23 CFR Part 655

National Standards for Traffic Control Devices; Revision of the Manual on Uniform Traffic Control Devices

ACTION: Final Amendments to the Manual on Uniform Traffic Control Devices (MUTCD).

R10-3b
225 mm x 300 mm
(9" x 12")

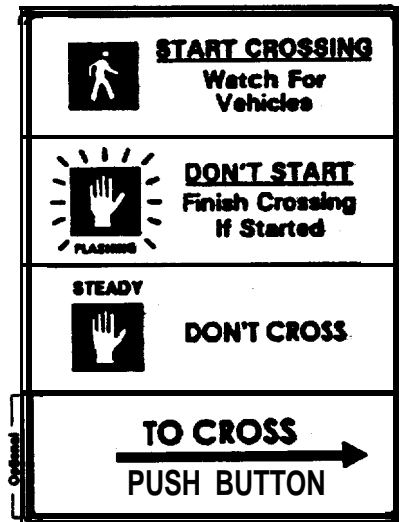
Request IV-124(C)—Educational Plaque for Pedestrian Signals

This amendment will allow the use of an educational plaque that can be used in conjunction with pedestrian signal indications. The FHWA is adopting the use of this optional educational plaque where both symbol-type and word message pedestrian signal indications are used.

A total of 27 of the 30 comments received agreed with the use of the educational plaque. The wording of the plaque shown in the notice of proposed rulemaking has been slightly modified to reflect the following comments:

1. After the wording DONT START use FINISH CROSSING IF STARTED.

2. Pedestrians should be aware of all vehicles, not just turning cars.

3. The highlighted flashing hand symbol is more easily understood.

5. Eliminate the wording WAIT ON CURB because all intersections do not have curbs.

6. Many intersections in the United States do not have push buttons for operating signals and, therefore, the bottom section of the sign with the caption "TO CROSS. . . PUSH BUTTON" should be made optional.

7. Since both symbols and word messages are allowed for pedestrian signal indications, two plaque designs are necessary.

Note: Word message (R10-3c) may be used in place of WALK/DON'T WALK symbol.
